NEW MEXICO OIL CONSERVATION DIVISION

Apache 25 Fed. #8
30-015-33439

Devon Energy
(234728)

RE: Form C-108, Application for Authorization to Inject
Apache 25 Federal #8; API# 30-015-33439
Eddy County, NM
Section 25, T22S, R30E

Apache 25#5:

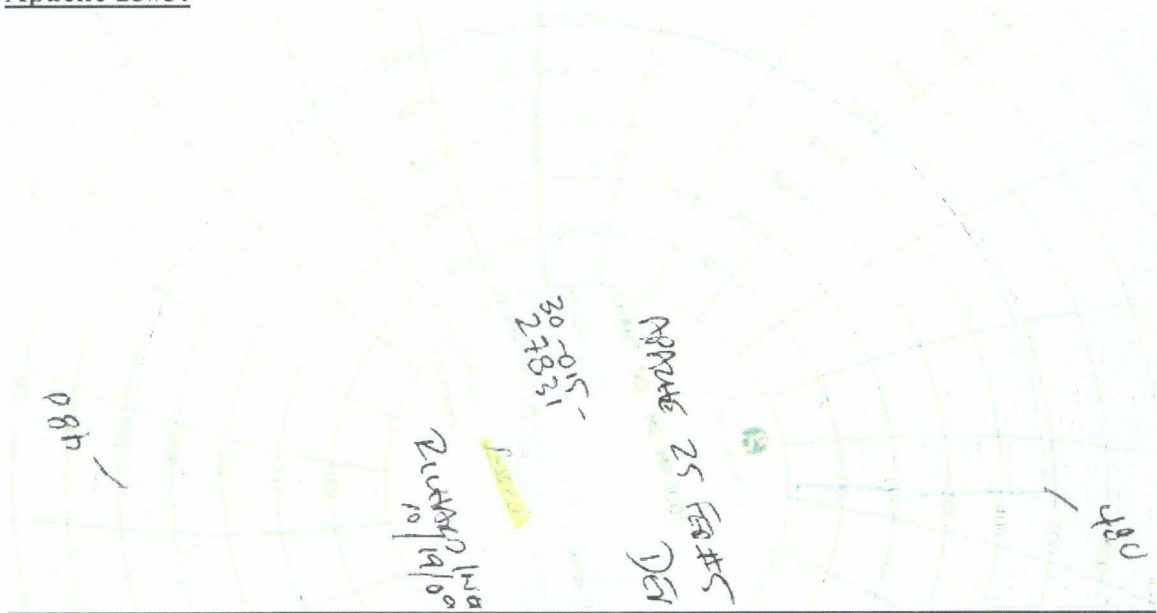
d. Would you send Bradenhead surveys and/or pressure tests on all intermediate-production casings within AOR to verify the cement top on production pipe is into the intermediate casing shoe and to verify there are no bradenhead flows. Please call our Artesia OCD office and ask if they wish to witness this work.

Here are the tests we received back from the field. I tried my best to scan these so that they were readable. If you enlarge the picture they seem to show up better. I didn't want to brighten the lines up, as to alter the data in anyway.
